# UPDATE Technical Bulletin

August 09, 2018

## UPDATE – 69V7 Atlas Quality Package (NVLW)

UPDATE Code 69V7 Atlas Quality Package

## Section D – Replace Instrument Panel Reset Button (Criteria 04)

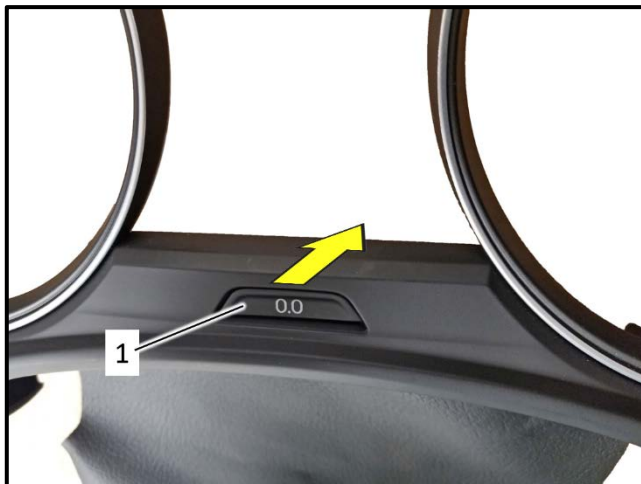
**Criteria 04:** Reset button sticks in the instrument panel. This can also cause the clock to reset on its own and/or DTC B123807: Instrument panel insert buttons mechanical malfunction.

**Criteria 04:** Due to excess material on the reset button, the reset button sticks.

**Criteria 04:** Redesigned button implemented in production.

- Press out the reset button <1> in direction of <arrow>.
- Install new reset button.
- Reinstall instrument cluster trim.
- Reassemble components in the reverse order of removal.
